RENESAS TECHNICAL UPDATE

Product Category	MPU/MCU	Document No.	TN-V85-A025A/E	Rev.	1.00
Title	Note about the RY output delay time of the clock synchronous serial interface (CSIG)		Information Category	Technical Notification	
Applicable Product	V850E2/Dx4 series V850E2/Dx4-H series	Lot No.	Reference Document	Data Sheet of each product	
		All lots

Figure 1. CSIG0SC and CSIG0RY timing chart

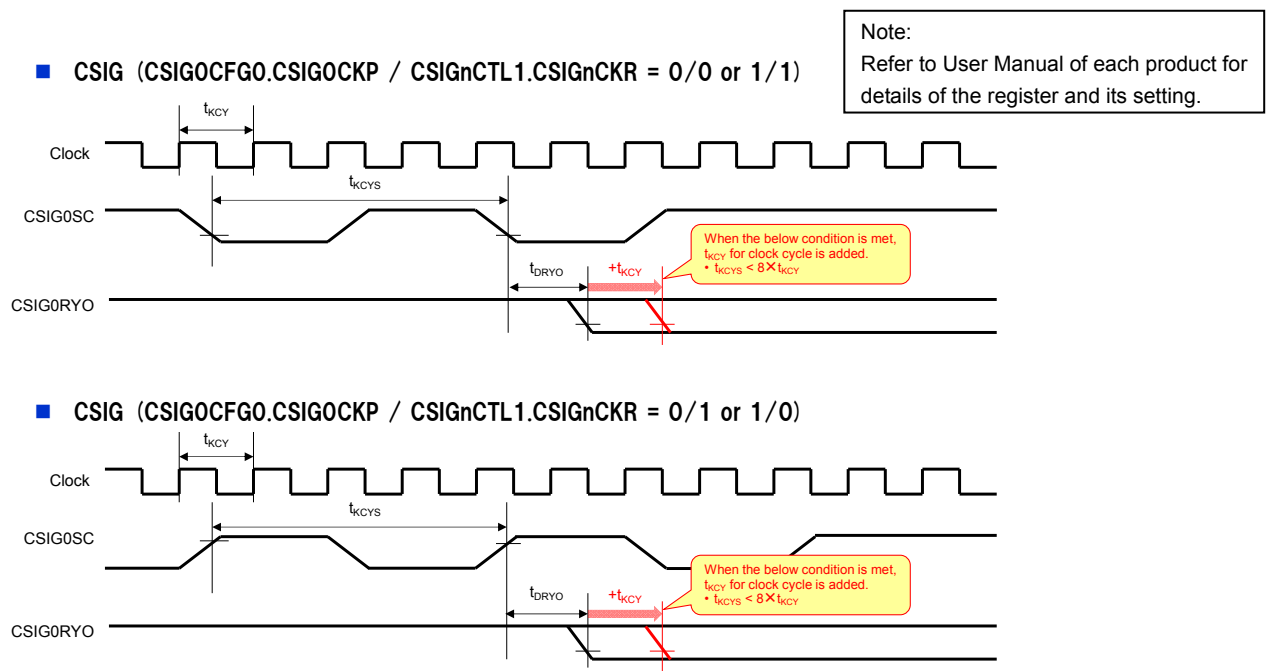
(1) Electrical characteristic change at the CSIG slave mode (CSIG0RY output delay time).

When CSIGNSC cycle time (t_{KCYS}) is smaller than 8 times of the Module clock cycle time (t_{KCY}) as following figure 1, 1 cycle t_{KCY} is added to the CSIG0RY output delay time (t_{DRYO}).

There is no spec change when CSIGNSC cycle time (t_{KCYS}) is more than 8 times of the Module clock cycle time.

The CSIG0RY output delay time (tDRYO) is changed as below.

Parameter	CT	Symbol	Condition		Ratings			Unit
					MIN.	TYP.	MAX.	
Ready / Busy output signal (CSIG0RY) output delay time (vs. CSIG0SC input) ^d	DS	tDRYO	filtered (DNF) ^a	$tKCYS \geq 8 \times tKCY$			30 + tdDNFSCI(max)	ns
				$tKCYS < 8 \times tKCY$			30 + tdDNFSCI(max) + tKCY	ns
			filter-bypassed ^c	$tKCYS \geq 8 \times tKCY$			30	ns
				$tKCYS < 8 \times tKCY$			30+tKCY	ns
